Permit Number 2023-P-1592-FP  
Job Address: Rector Loop, Manor, TX. 78653

The first submittal of the Shadowglen Phase 3 Section 2 Final Plat (*Final Plat*) submitted by Kimley-Horn and received on March 26, 2024, have been reviewed for compliance with the City of Manor Subdivision Ordinance 263B.

**Re: Project: 2023-P-1592-FP  
Shadowglen Phase 3 Section 2 Final Plat  
Engineering Comments**

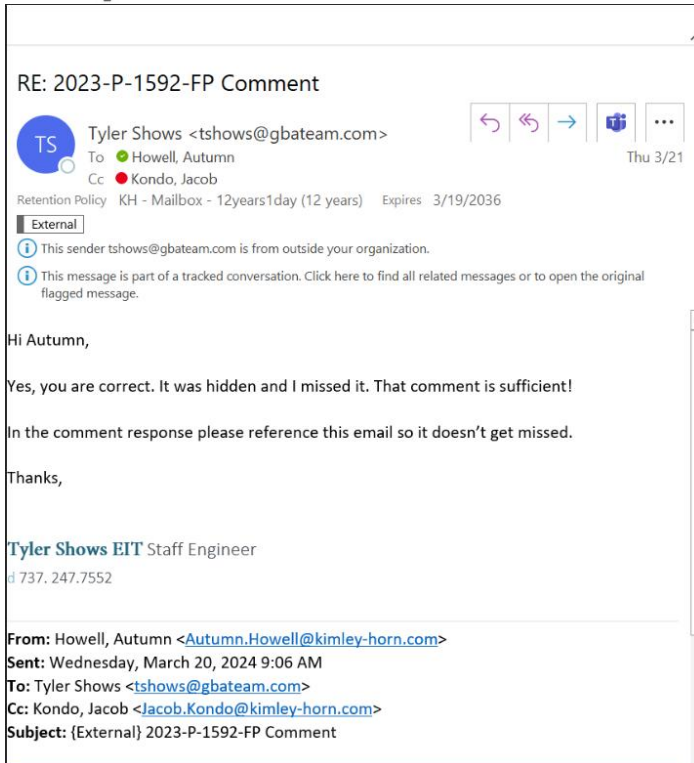
5. True bearings and distances to the nearest established street lines, official monuments, or existing subdivision corner which shall be accurately described on the plat and rotated to the state plane coordinate system. **Using said system, X and Y coordinates shall be identified for four (4) property corners. Only called out for 3 property corners.**

**Response: All four corners of the project have been called out with a Northing and Easting. Please see the email thread attached with this submittal. A snippet of the email response is also shown below.**
